Access Compliance Report

Public Rights-of-Way

(Curb Ramps)

Intersection ID: 47275	Main Street: CARRINGTON_FOREST_LN	Cross Street: GREYSTONE_PARK_LN	Location: SW
ADA ID: 7626824F7892	Ramp Type: BlendTrans1	Initial Pass/Fail: Fail	Overall Compliance: No
Severity Score: 8.75			
Codes/Mitigation Info/Possible Solution		Field Measurements/Component Compliance

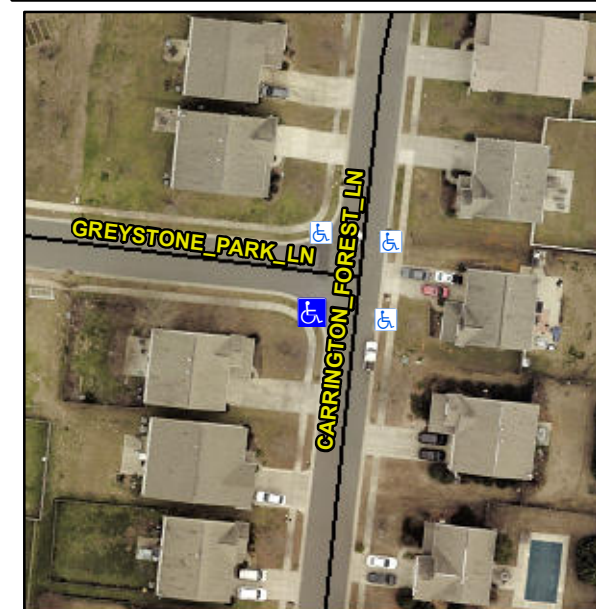
Not Found, R304.5.1

Compliance	Description	Data	Compliance	Description	Data
N/A	Ramp Length (in)	49.8	Yes	BlendTrans Slope (%)	3.4
No	Ramp Width (in)	46.0	Yes	BlendTrans XSlope (%)	0.2
N/A	Flare Type LT	N/A	N/A	Flare Type RT	N/A
N/A	Flare Slope LT (%)	N/A	N/A	Flare Slope RT (%)	N/A
N/A	Flare Traversable LT?	N/A	N/A	Flare Traversable RT?	N/A
N/A	Landing Length (in)	N/A	N/A	DWS Provided?	N/A
N/A	Landing Width (in)	N/A	N/A	DWS Contrast?	N/A
N/A	Landing Slope (%)	N/A	N/A	DWS Length (in)	N/A
N/A	Landing X Slope (%)	N/A	N/A	DWS Full Width?	N/A
N/A	Landing Curb? (Y/N)	N/A	N/A	DWS Offset (in)	N/A
N/A	Shared Landing?	N/A			
N/A	Gutter Ponding?	N/A	N/A	Gutter Slope (%)	N/A
N/A	Gutter Lip Ht (in)	N/A	N/A	Gutter X Slope (%)	N/A
N/A	Painted X Walk1?	No	N/A	Painted X Walk2?	No
	X Walk 1 Direction	To E		X Walk 2 Direction	To N
	X Walk 1 Width (in)	N/A		X Walk 2 Width (in)	N/A
	X Walk 1 Slope (%)	0.6		X Walk 2 Slope (%)	2.9
	X Walk 1 X Slope (%)	3.5		X Walk 2 X Slope (%)	2.4

N/A	Ramp inside XWalk1?	N/A	N/A	Ramp inside XWalk2?	N/A
	Road Slope (%)	1.7		Clear Space?	N/A
	Road X Slope (%)	3.3	N/A	Clear Space to XWalk (in)	N/A
N/A	Any Obstructions?	N/A	N/A	Storm Grate/Utility Hazard?	N/A
	Obstruction Type			Storm Grate/Utility Type	
		N/A			N/A
			Yes	Surface Condition? (G/P)	Good
			No	Curb Slope (%)	11.1

Remove & Replace Curb Ramp With Two New Directional Ramps or Equivalent.
